SERVICE BULLETIN

APPLICABILITY: 2012-13MY Impreza 2.0L Models
2013MY XV Crosstrek

NUMBER: 12-157-13

SUBJECT: Rattle or Buzzing Sound from “A” Pillar Trim

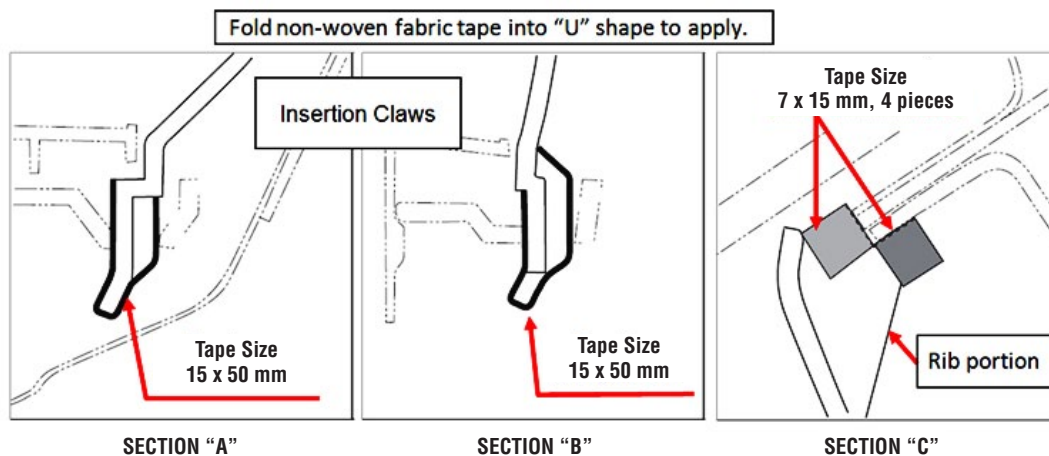
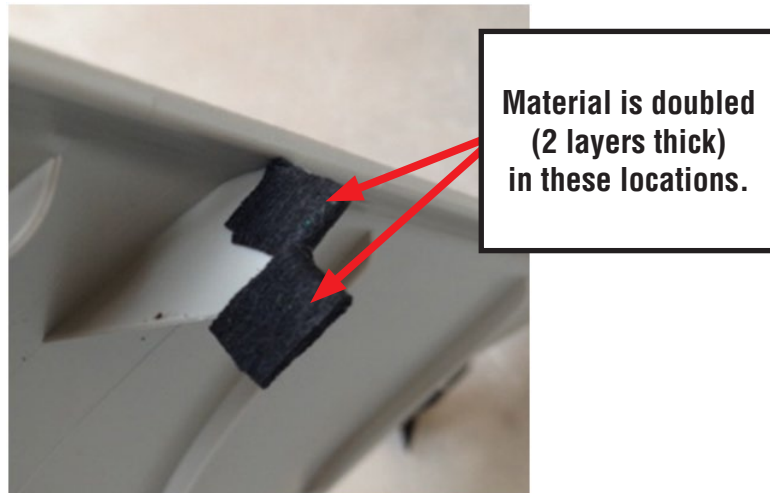
This bulletin provides a repair procedure to address a customer concern of a rattle or buzzing-type sound coming from the lower portion of the “A” pillar trim while driving over bumpy or rough road surfaces. The lower insertion claws and / or the trim’s support rib may be coming in contact with the vehicle body causing the sound.

- With the “A” pillar trim at room temperature, clean the 3 areas shown in the illustration below (A, B, and C) with rubbing alcohol applied to a clean shop cloth then allow to dry before installing the non-woven material.

- Cut the non-woven material pieces to size then peel the adhesive backing and apply to the insertion claws and rib portion as shown in the illustration below.

Non-woven fabric tape has been applied to the “A” pillar trim in production from February 1, 2013.

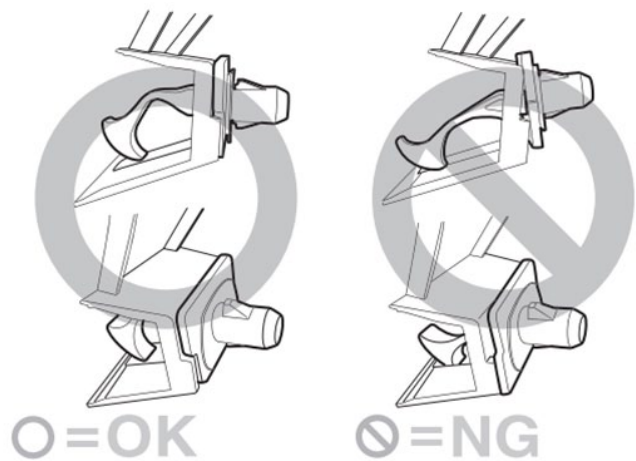
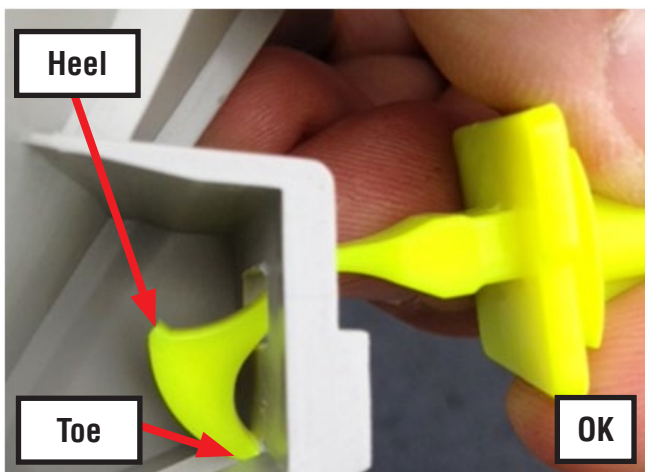
- For section C, the material must be doubled (2 layers thick) to achieve the required thickness as shown in the photo below.

- Once all the non-woven material pieces are in place, re-install the “A” pillar trim using a **NEW** tether clip.

IMPORTANT: The tether clips are **one-time use items** and **must** be replaced any time they are removed. Additionally, the tether clip must be installed into the “A” pillar trim in the proper direction. See the photo and illustrations below for proper installation details.
